Trudeau Building Rehabilitation

Addendum #2: Historic Saranac Lake – Trudeau Building Rehabilitation
PROJECT LOCATION: Reconstruction at 118 Main Street, Saranac Lake, NY 12983
Issue Date: February 5th, 2023

Please be advised of the changes noted below to the Bidding documents and responses/answers to requests for information and questions received to date during the bidding period.

ARCHITECT OF RECORD

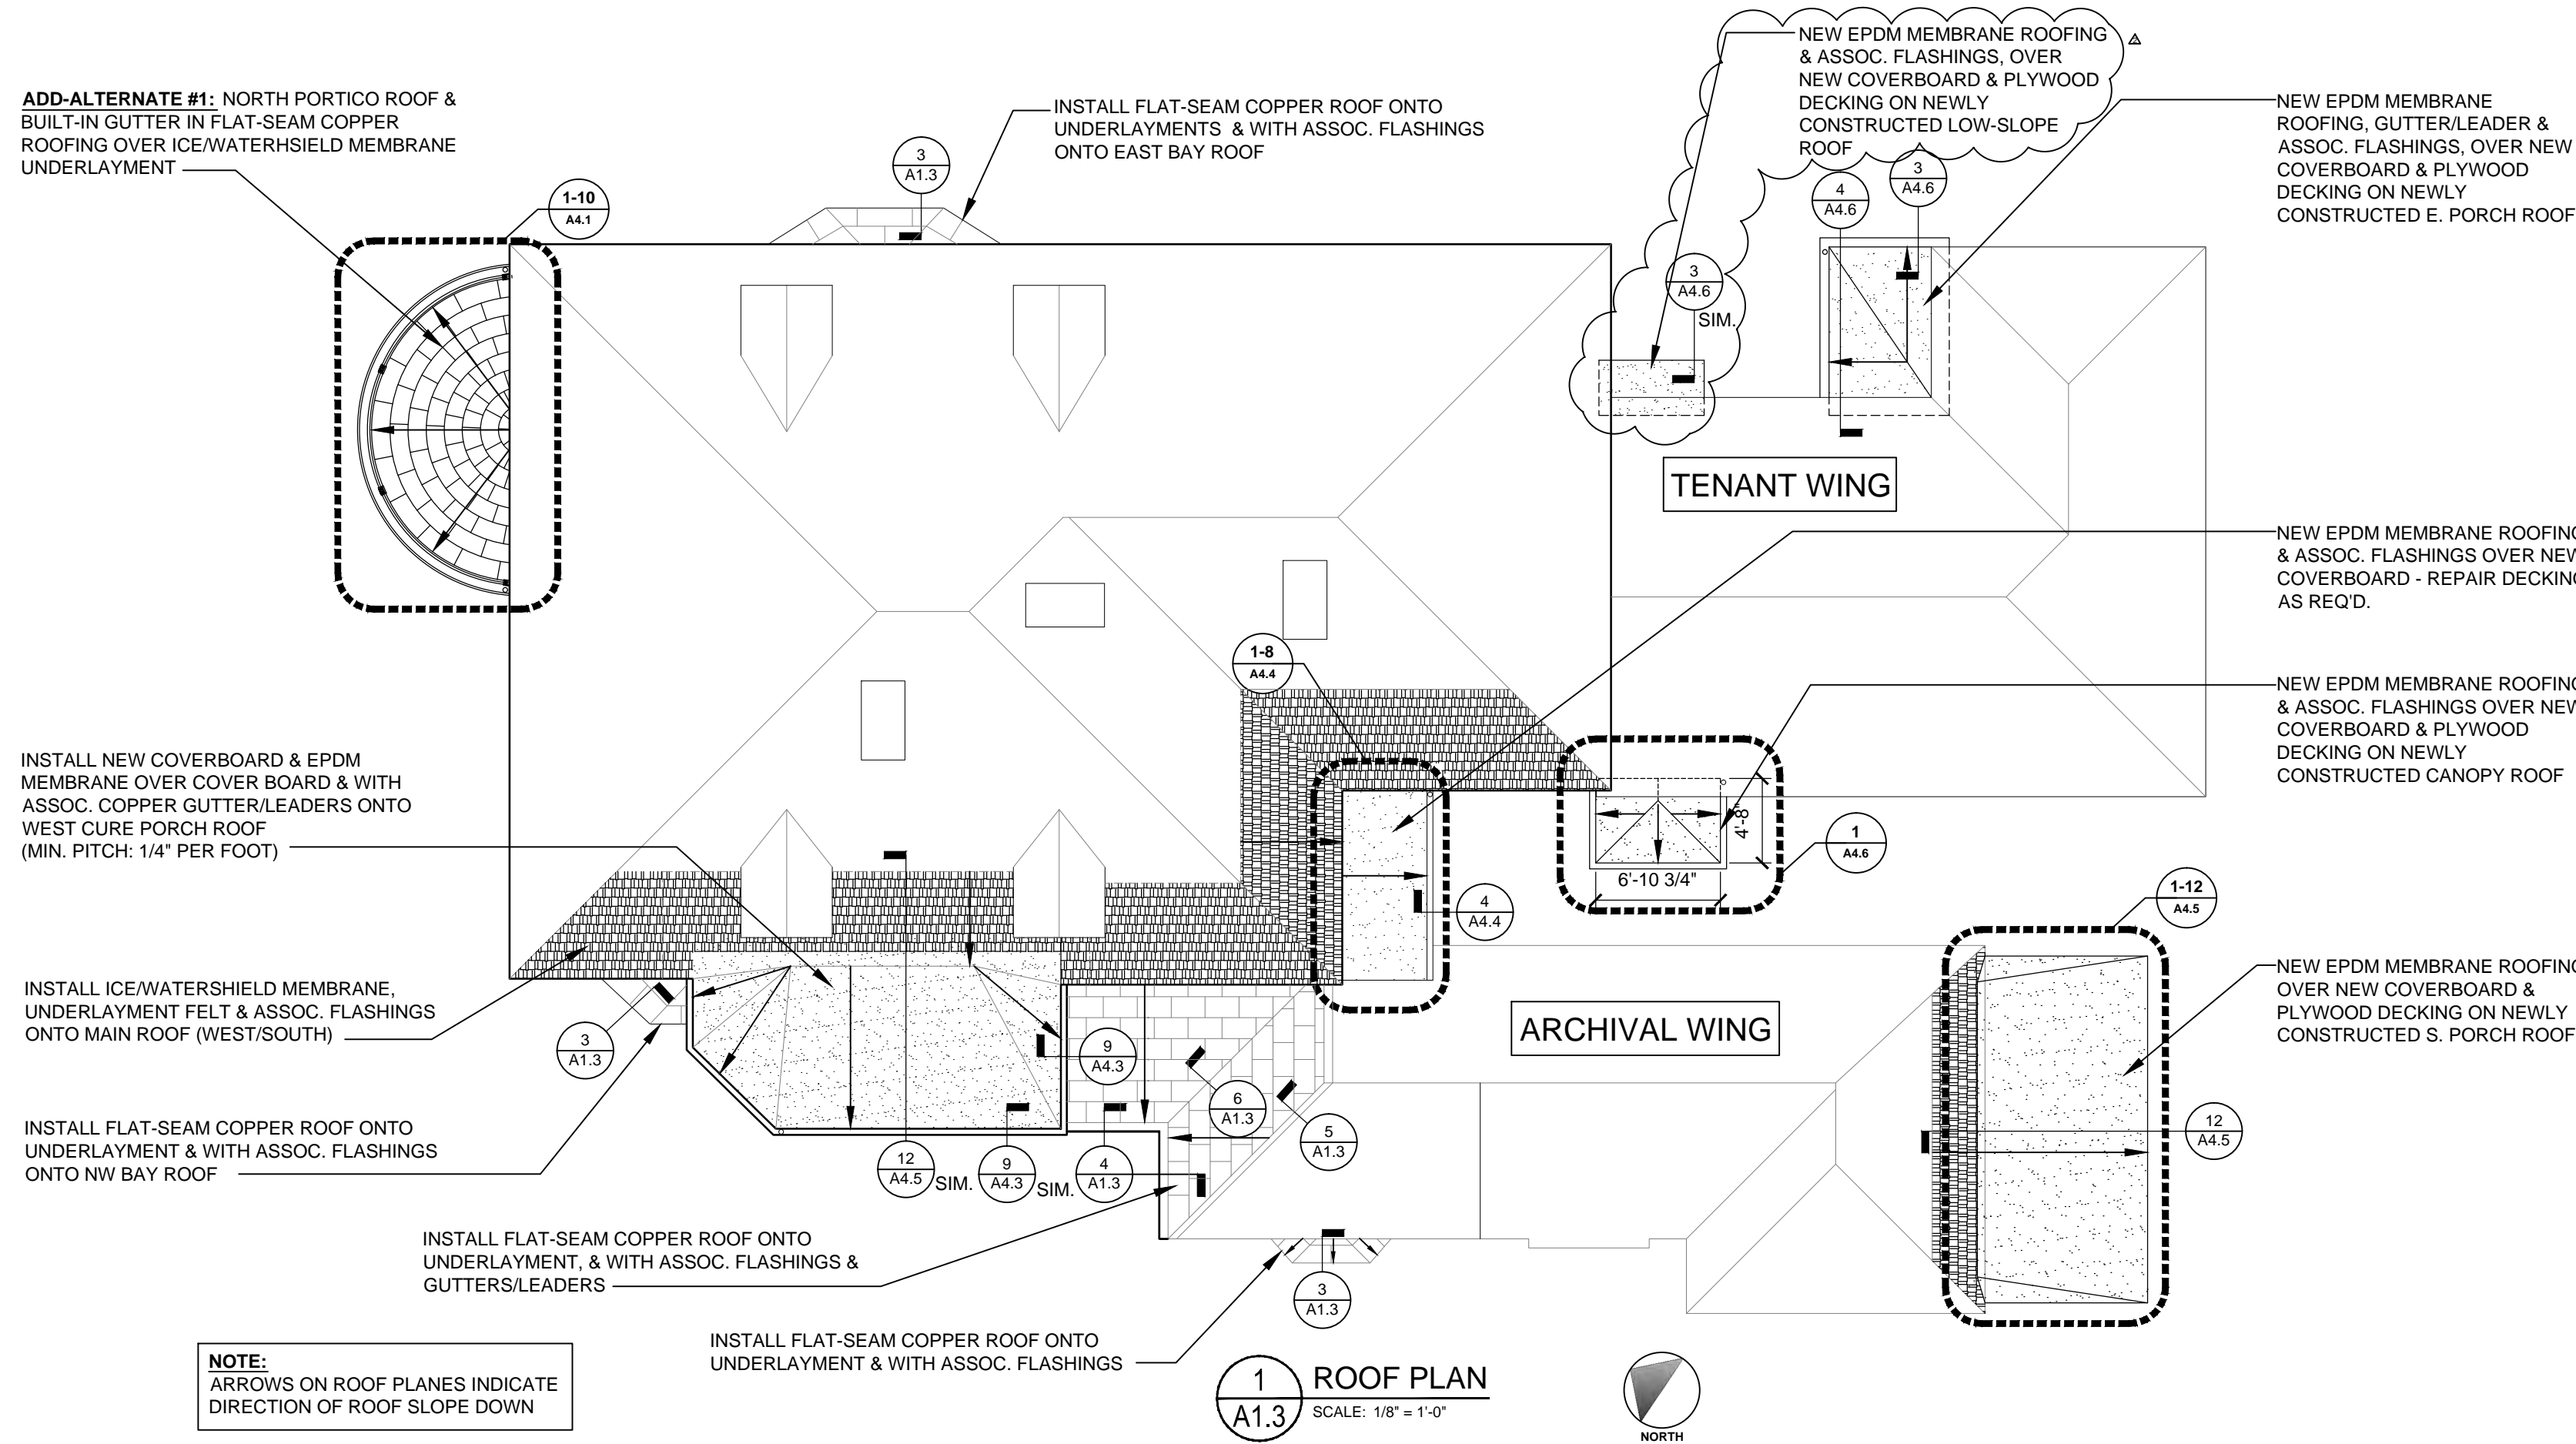
1. 1&2/A1.11: First & Second Floor Reflected Ceiling Plans
 - a. Ceiling types have been indicated with a ceiling type number within a box in selected rooms where there is new gypsum wall board anticipated to be fastened to existing plaster ceilings or exposed ceiling joists (Ceiling Type 6), the installation of suspended acoustic ceiling tile beneath existing plaster or gwb ceilings (Ceiling Type 7) or wood beaded board ceiling within porches & North Portico (Ceiling Type 8) or suspended gypsum wall board (Ceiling Type 9).

- b. Horizontal chases in Rooms 104 and 117 now have a dimension shown as well as ceiling height above finished floors. Also shown is the vertical chase in the NW corner of Office 124 that contains a new 8x8 duct connecting the energy recovery unit in the crawlspace below 124 with the horizontal chase in 117. Detail 3/A5.3 is referenced on both horizontal chases in Gallery 104 and Office 124.

3 A.C.T./G.W.B./HORIZONTAL CHASE DETAIL
A5.3 SCALE: 3" = 1'-0"

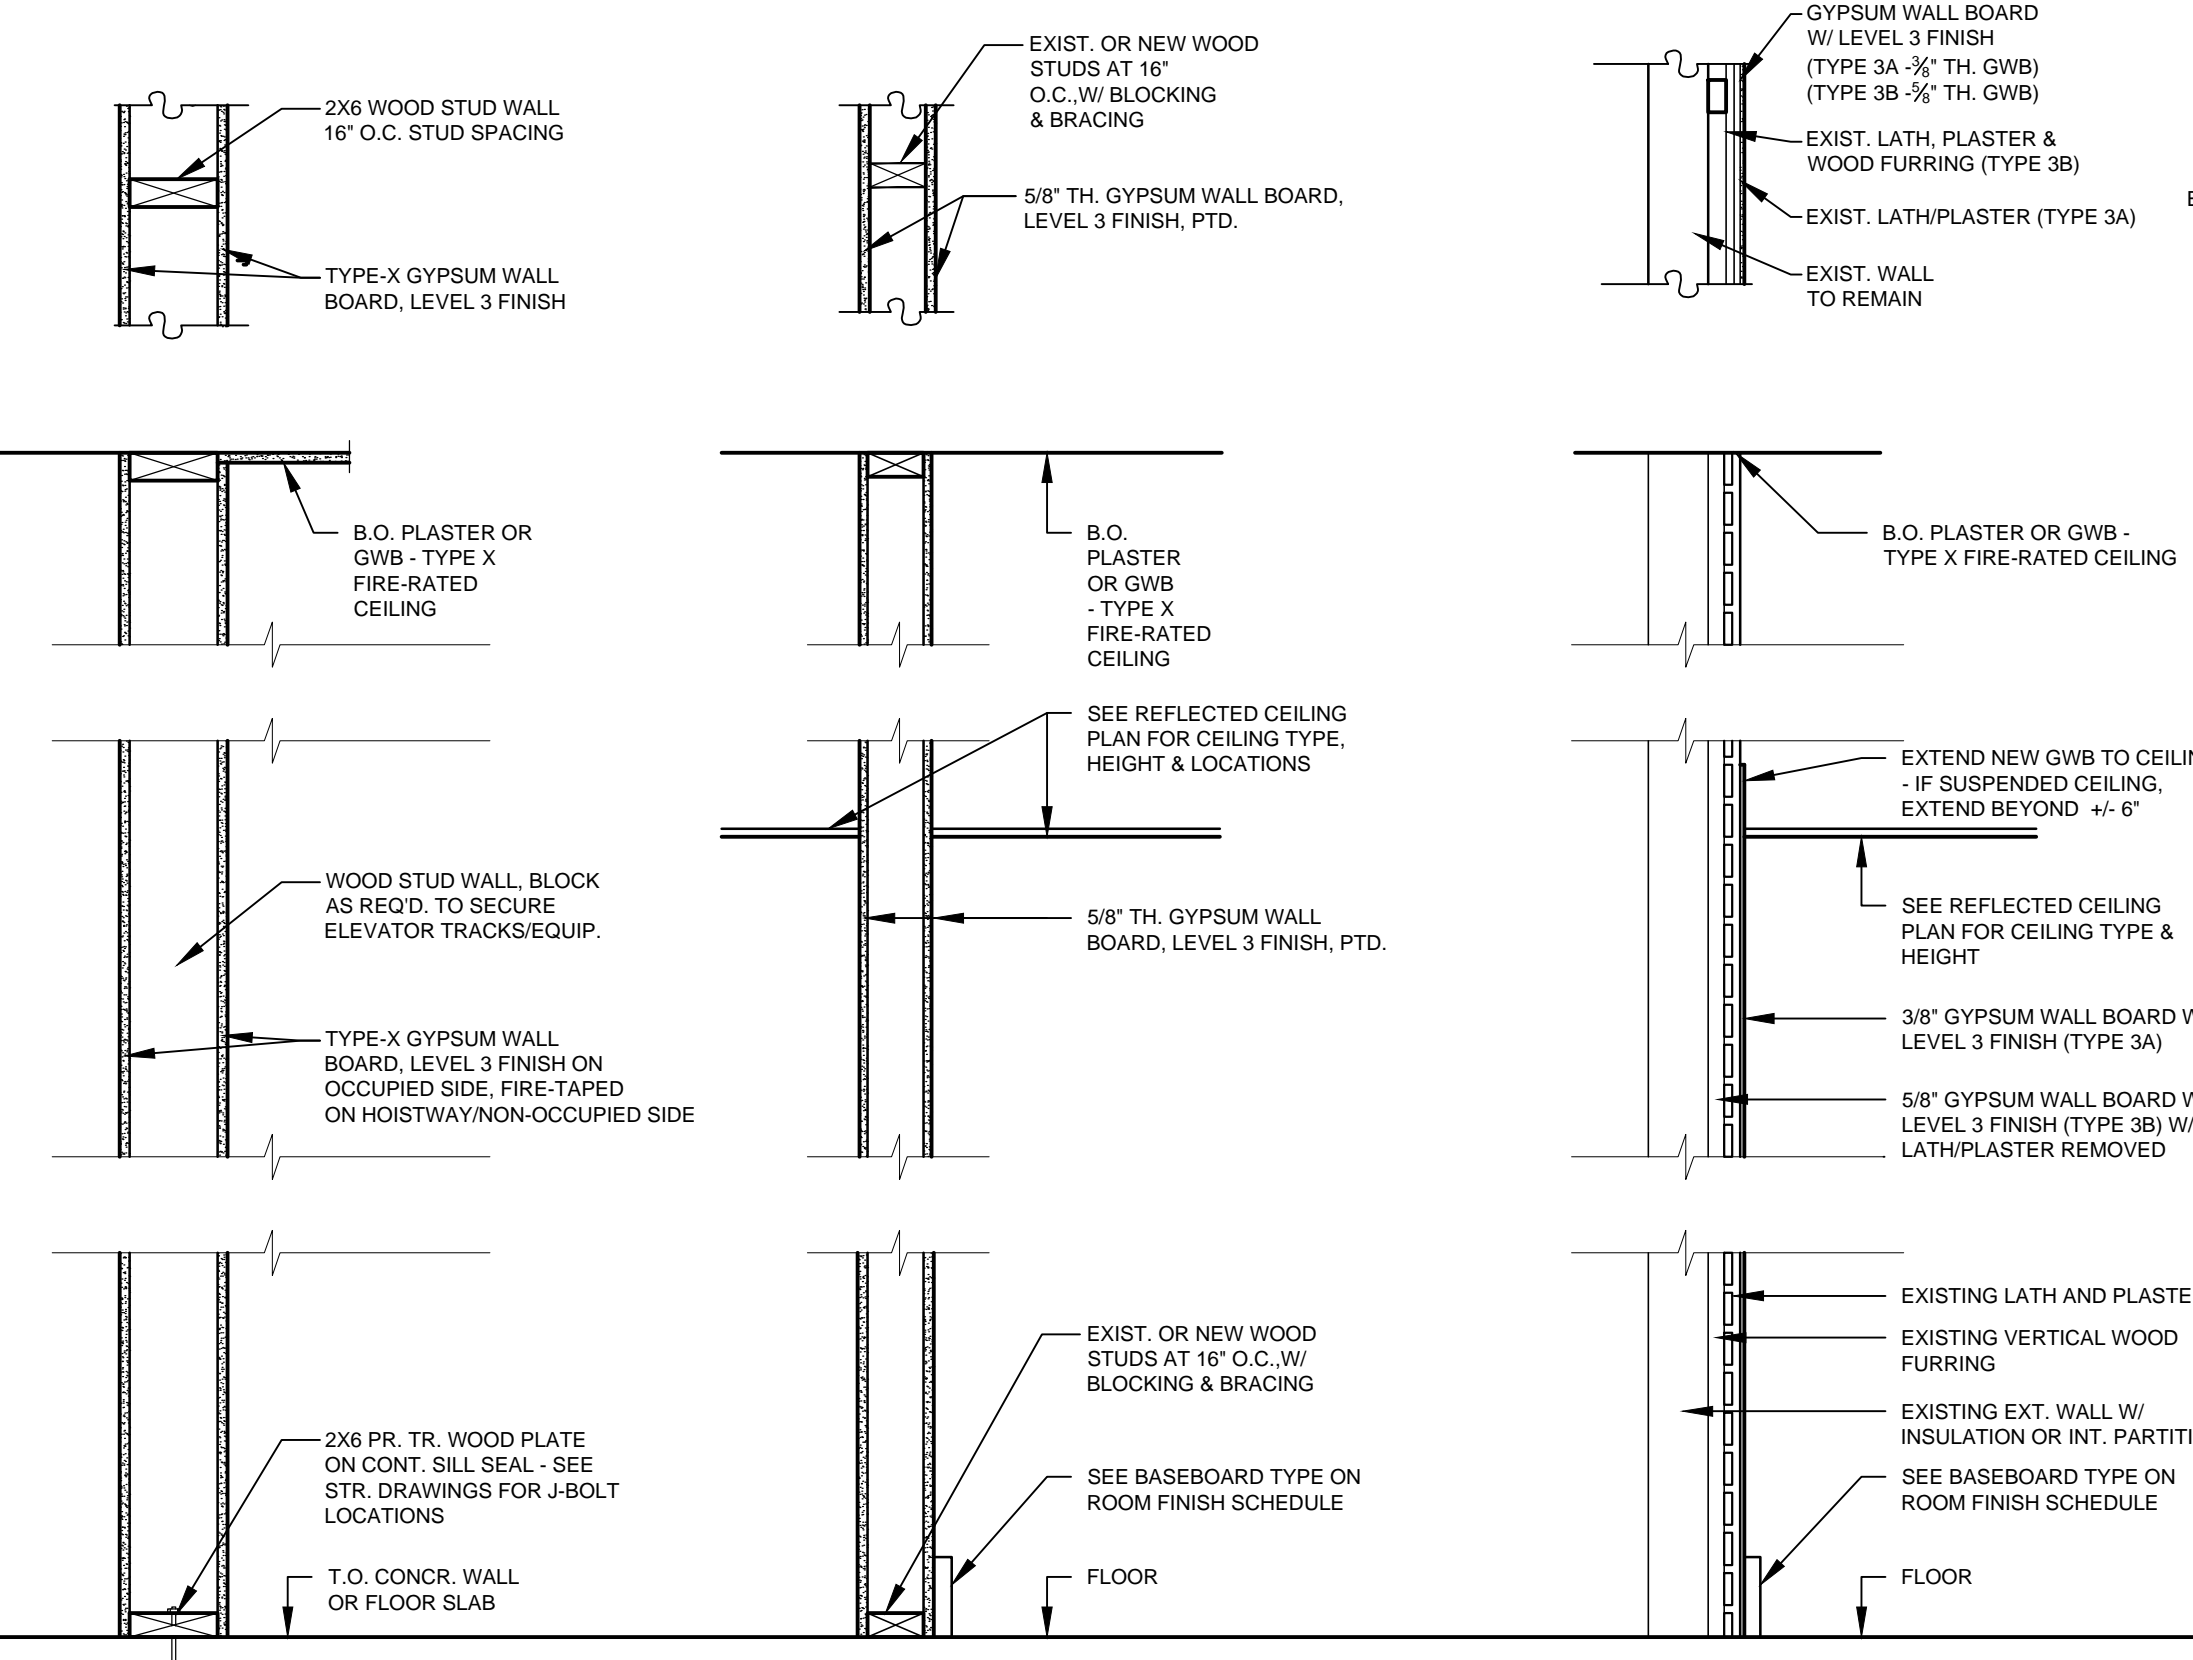
1. 3/A1.3: Acoustic Ceiling Tile/Gypsum Wallboard/Horizontal Chase Detail revised
 - a. Detail revised to reflect horizontal chase and ceiling construction needed in Gallery 104 where the ceiling is gypsum wall board **Type 6** and Reception 117 where the ceiling is suspended acoustic ceiling tile, **Type 7**.

4 WALL TYPES
A5.3 SCALE: 1" = 1'-0"

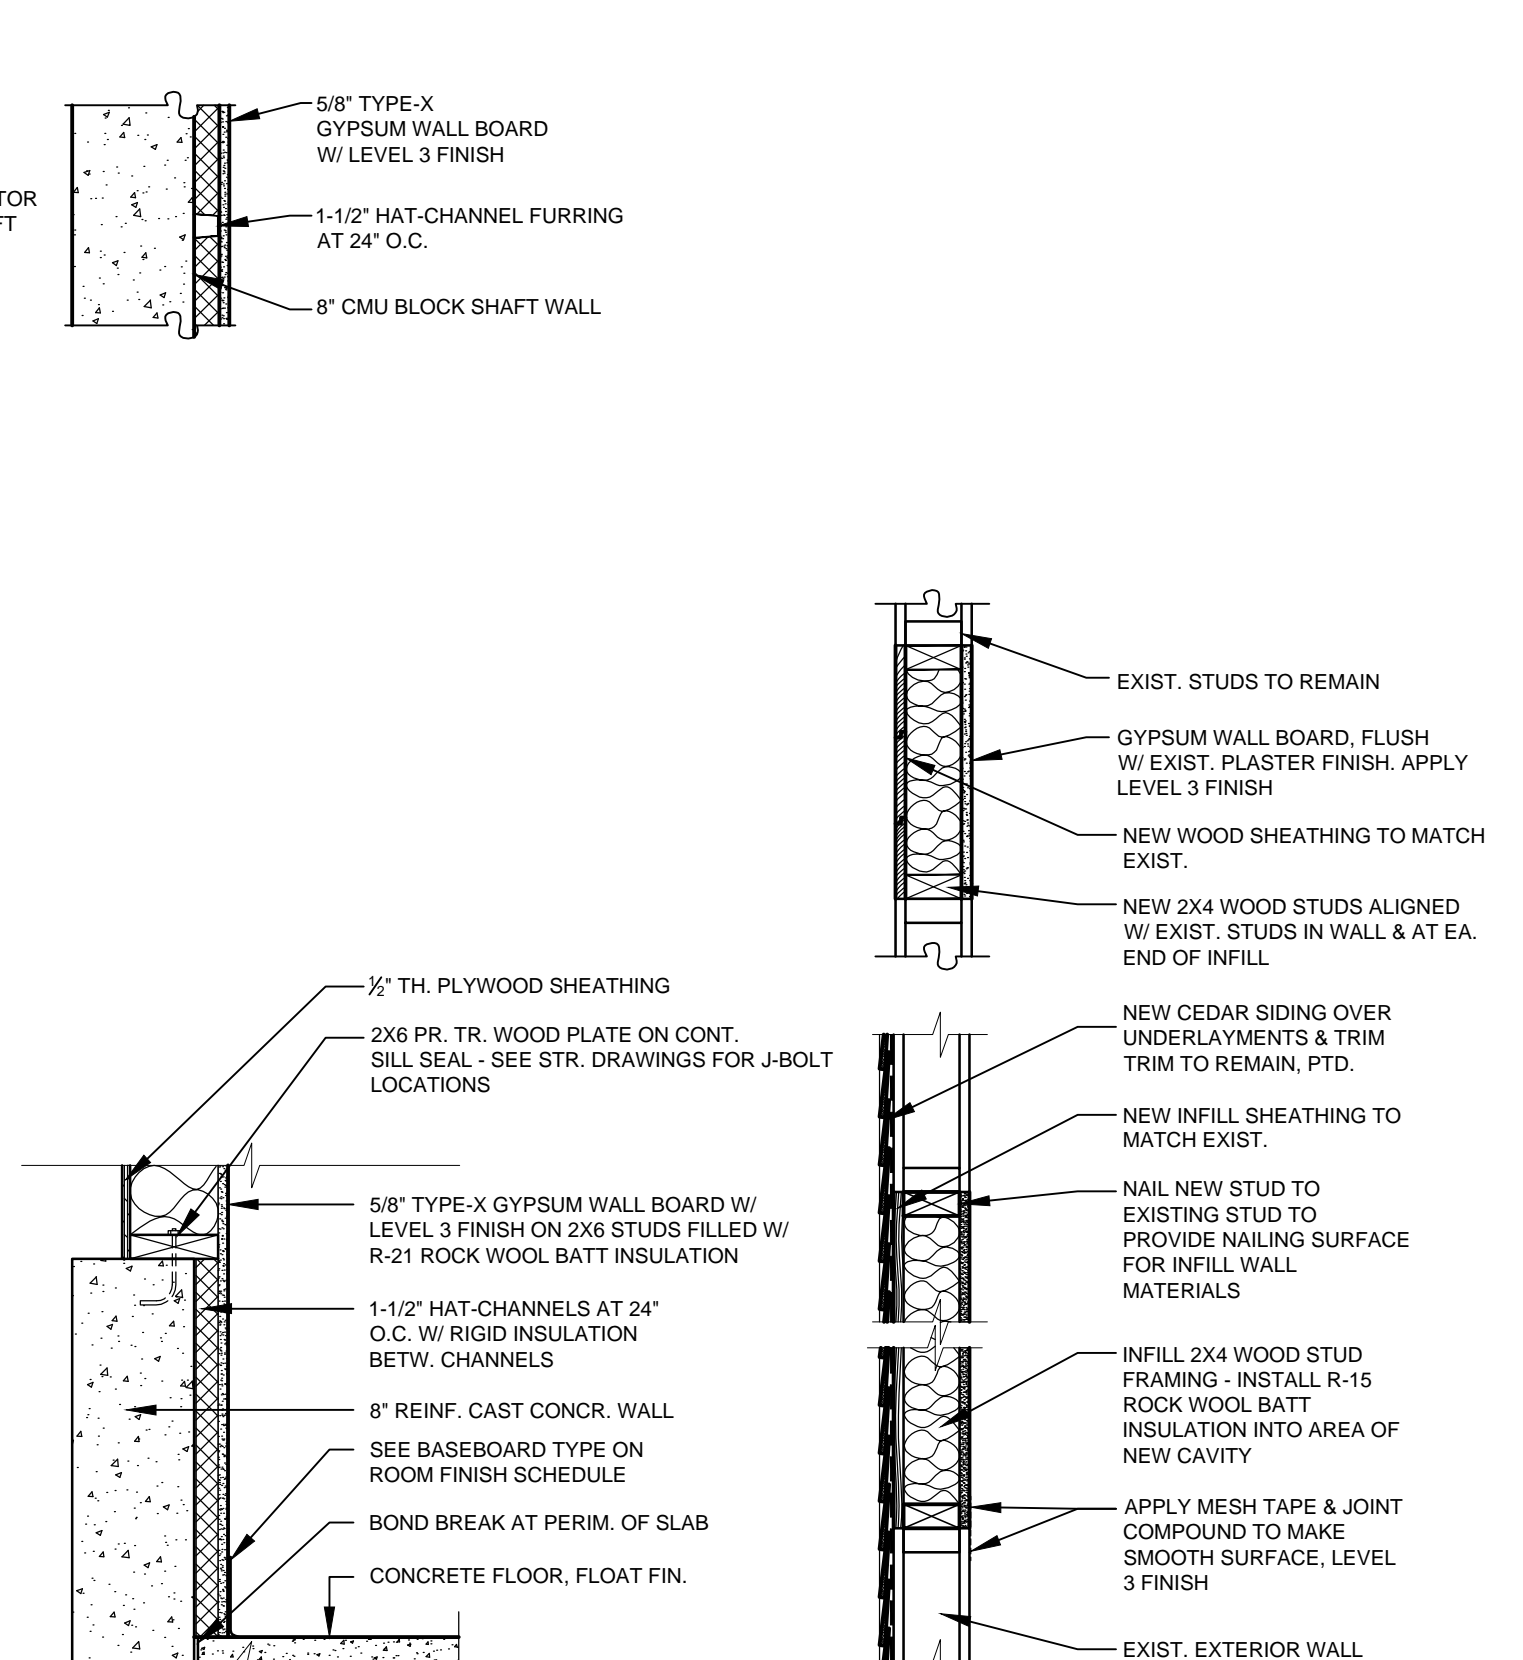
2. 4/A5.3: Wall Types
 - a. Wall Type 2D added: new wall construction using 2x3 (or 2x4) wood studs with 5/8" GWB on occupied room side of wall forming vertical duct chase for an 8x8 fresh air duct in Office 124.
